# Access Compliance Report

## Public Rights-of-Way

### (Curb Ramps)

Intersection ID: 2907	Main Street: EVERGREEN_HOLLOW_DR	Cross Street: GOLDENFIELD_DR	Location: W
ADA ID: DDD52F287E44	Ramp Type: PerpDiag	Initial Pass/Fail: Fail	Overall Compliance: No
Codes/Mitigation Info/Possible Solution		Field Measurements/Component Compliance

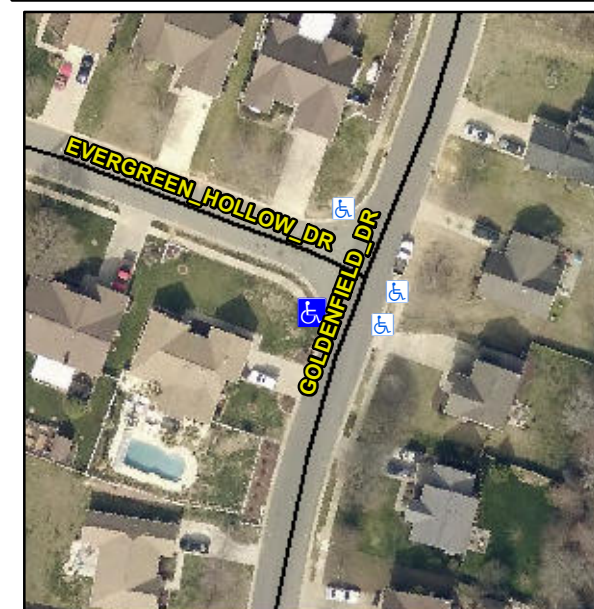
**Not Found, R304.2.2, R304.5.3**

Compliance	Description	Data	Compliance	Description	Data
N/A	Ramp Length (in)	47.0	No	Ramp Slope (%)	9.2
Yes	Ramp Width (in)	48.0	No	Ramp XSlope (%)	3.0
N/A	Flare Type LT	N/A	N/A	Flare Type RT	N/A
N/A	Flare Slope LT (%)	N/A	N/A	Flare Slope RT (%)	N/A
N/A	Flare Traversable LT?	N/A	N/A	Flare Traversable RT?	N/A
N/A	Landing Length (in)	N/A	N/A	DWS Provided?	N/A
N/A	Landing Width (in)	N/A	N/A	DWS Contrast?	N/A
N/A	Landing Slope (%)	N/A	N/A	DWS Length (in)	N/A
N/A	Landing X Slope (%)	N/A	N/A	DWS Full Width?	N/A
N/A	Landing Curb? (Y/N)	N/A	N/A	DWS Offset (in)	N/A
N/A	Shared Landing?	N/A			
N/A	Gutter Ponding?	N/A	N/A	Gutter Slope (%)	N/A
N/A	Gutter Lip Ht (in)	N/A	N/A	Gutter X Slope (%)	N/A
N/A	Painted X Walk1?	No	N/A	Painted X Walk2?	No
	X Walk 1 Direction	To SE		X Walk 2 Direction	To NE
N/A	X Walk 1 Width (in)	N/A	N/A	X Walk 2 Width (in)	N/A
	X Walk 1 Slope (%)	7.1		X Walk 2 Slope (%)	5.1
	X Walk 1 X Slope (%)	4.1		X Walk 2 X Slope (%)	4.0

**Remove & Replace Curb Ramp With Two New Directional Ramps or Equivalent.**
